Save Our Island (Hayling) wishes to register an objection to the Southern Water Hampshire Water Transfer & Water Recycling Project Development Consent Order Application, and to also confirm my agreement with the Havant Water Matters' Community response.

APPENDIX 1 EA Flood Risk Map of Budds Farm & the recycling site

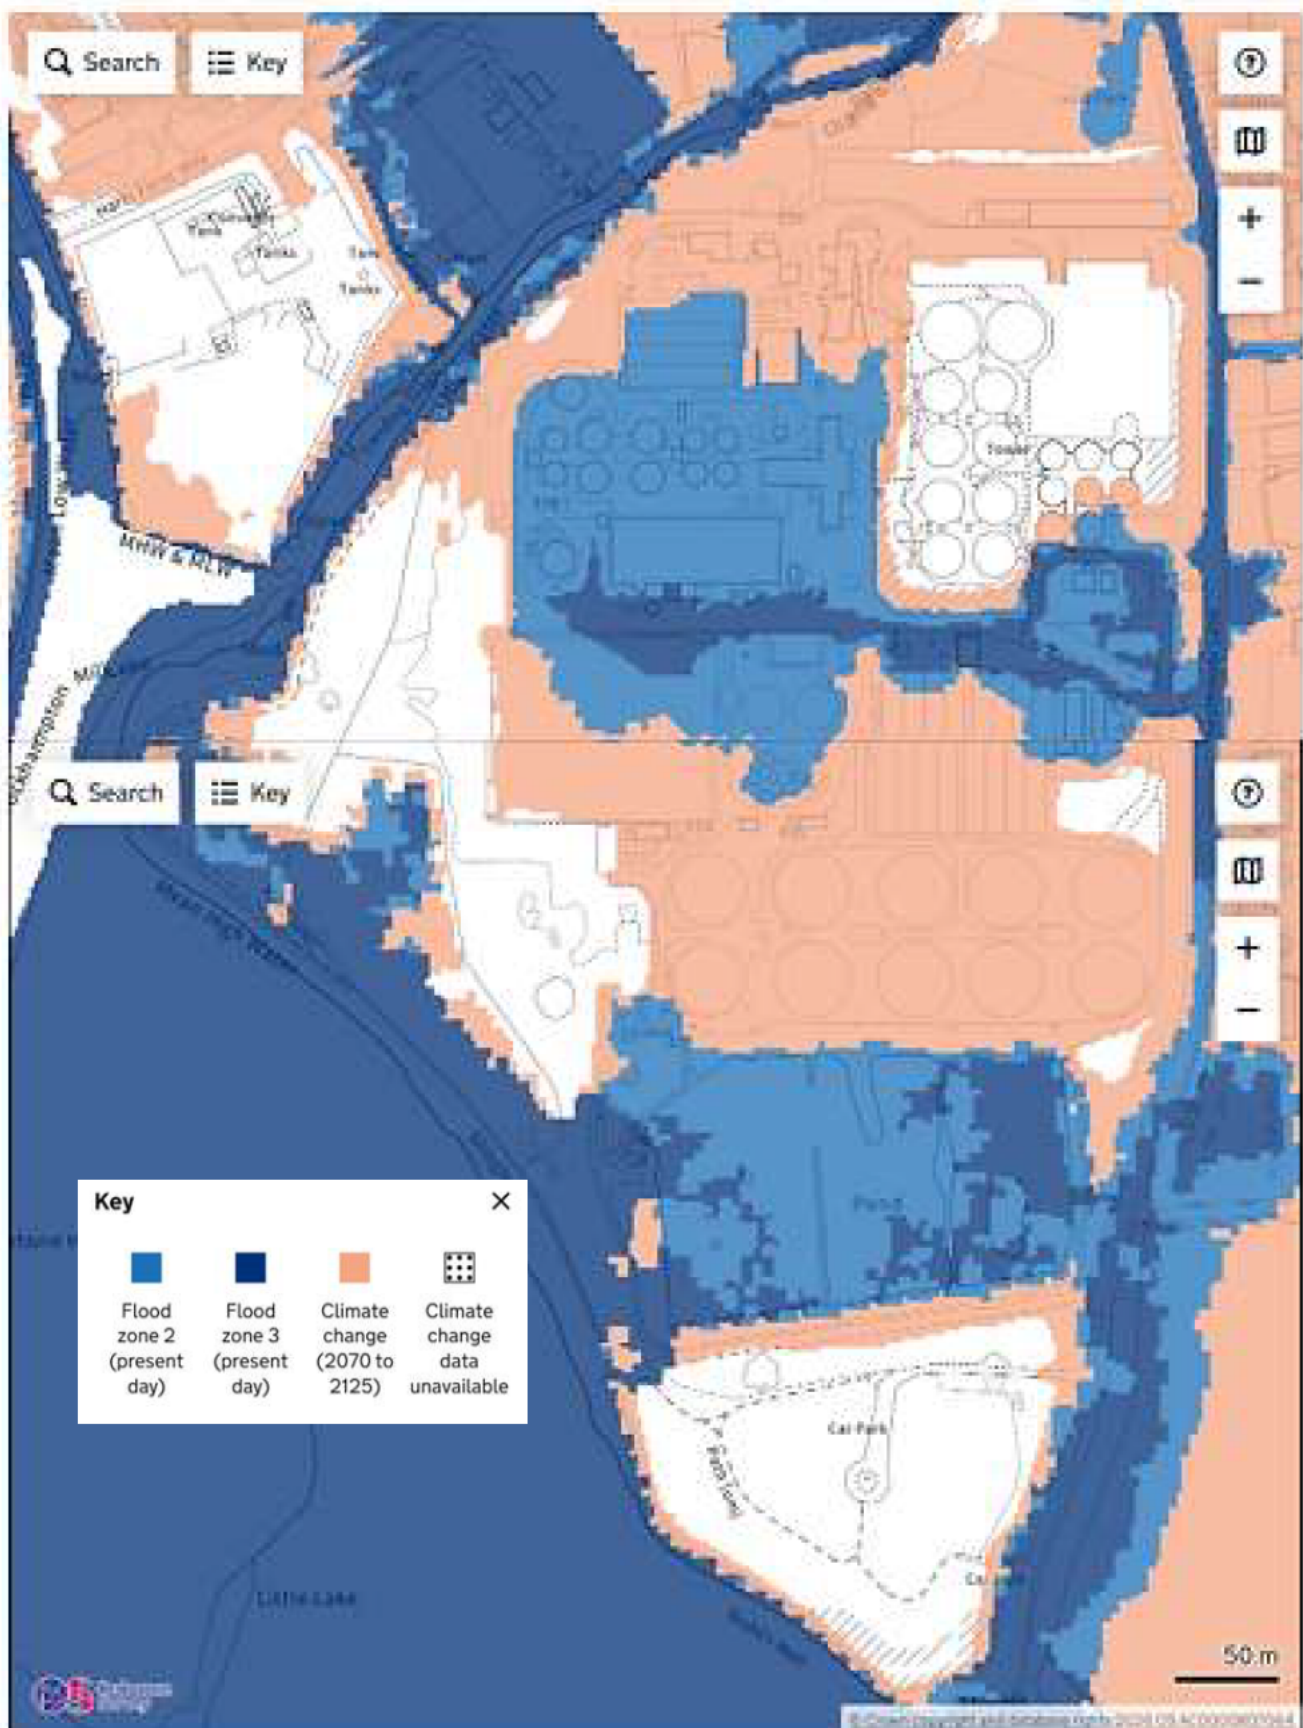
The DCO makes clear the proposal is an integrated system from the WTW through treatment and via the pipe network to Havant Thicket and onwards to Otterbourne. This is a 24/7 continuous process and is expected to be in place for 100 years or more ([APP-082 3.7 page 83](#)). On the EA Flood Risk Map showing Budds Farm & the recycling site (see APPENDIX 1), the major portion of the other essential components located at Budds Farm and the access routes are at Cat 2, 3 and Climate Change flood risk. The PC, MCC and WRP sites are planned to be raised up – the rest of the site and access routes are not (see APPENDIX 2). This DCO elevates the significance of this location as a major national utility (to a NSIP Nationally Significant Infrastructure Project.)
